## Examination of the North Hertfordshire Local Plan 2011 - 2031

### Response of North Hertfordshire District Council to the Inspector's note of 29 October 2018

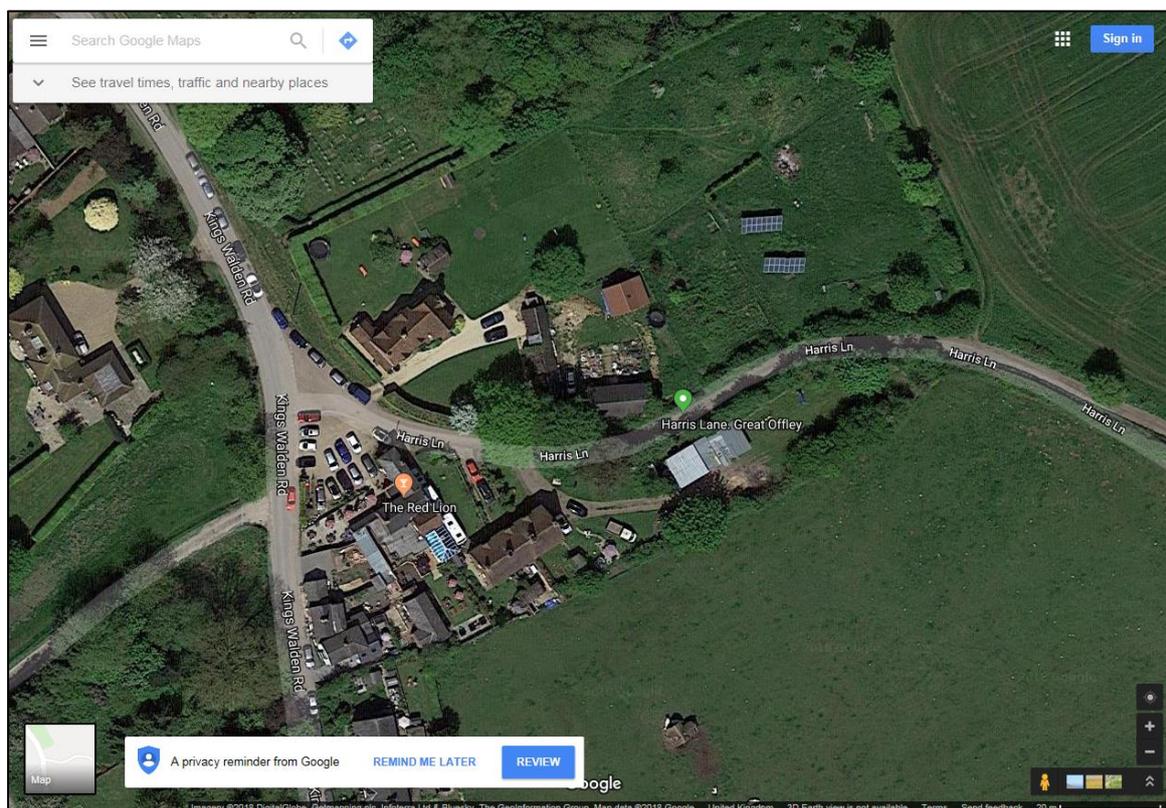
23. During the hearing discussion concerning Offley, the Council proposed to modify the settlement boundary to the north of Harris Lane to reflect the planning permission given by the Council and to re-define the green belt boundary using the belt of trees to the north west as the 'defensible boundary'. However, from MM393 and the accompanying map, it appears that land to the south of Harris Lane has also been removed from the green belt. Please explain the rationale for this.

*The proposed Green Belt boundary to the south of Harris Lane as shown on the submission Policies Map and the 'before modifications' map does not follow any defined feature on the ground; it was drawn as a continuation of the now superseded boundary that was proposed to the north of Harris Lane.*

*Following the modification of the Green Belt boundary to the north of Harris Lane, the rear boundaries of the properties to the south of Harris Lane, which provide separation from the agricultural field beyond, form the most appropriate defensible boundary having regard to Paragraph 85 of the 2012 NPPF. This is illustrated by the aerial photograph attached below.*
